# **Environmental Impact Statement (EIS) Assessment Report for the Washpool Coal Mine Project**

May 2012

Prepared by: Statewide Environmental Assessments, Department of Environment and Heritage Protection

**Figure 1 - Typical cross section of rejects disposal spoil profile**

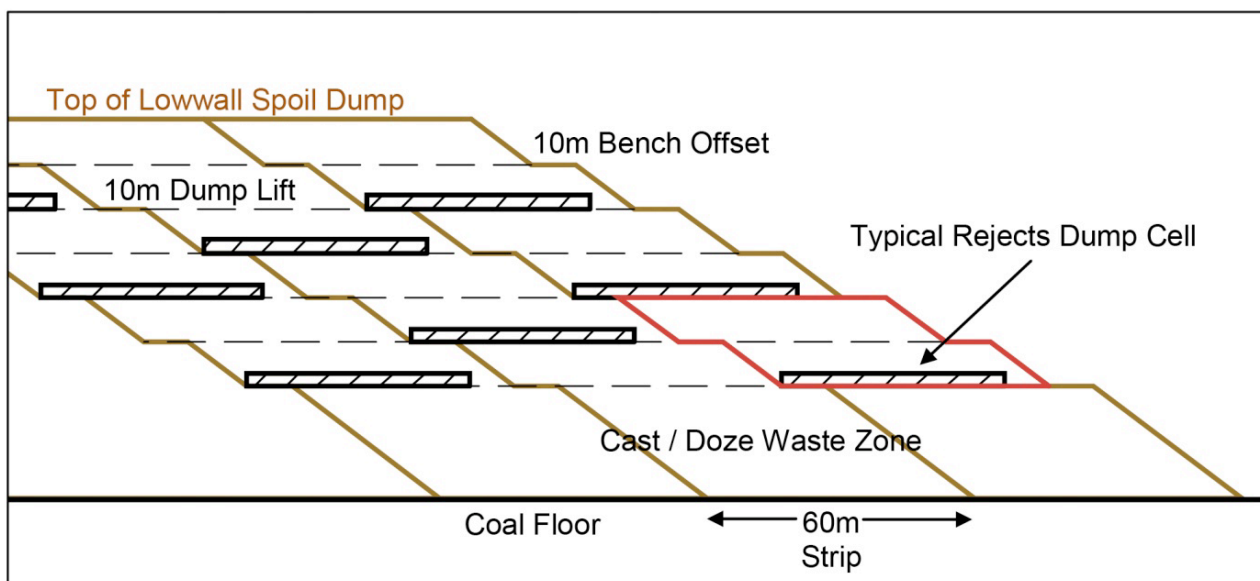
- co-disposing into active tip faces during overburden removal from the pits
- encapsulated in reject cells shown in Figure 1 of this report.

The proponent stated that at no point shall rejects be dumped outside the geotechnical placement design which includes low walls, outside edges of dumps and the highest and lowest tiers of the dumps, thus ensuring the rejects are encapsulated.

The former DERM provided a submission requesting the proponent to provide detailed information on the management of overburden and reject material. In the EIS Addendum (January 2012), the proponent provided adequate information on the management of overburden material, including dewatered fines and coarse rejects. That additional information included the figure below (Figure 1) showing how reject material would be encapsulated in cells buried in-pit.

It is recommended that the draft EA include conditions requiring disposal of reject material by encapsulation within the in pit waste dumps as shown in Figure 1, Typical cross section of rejects disposal spoil profile.
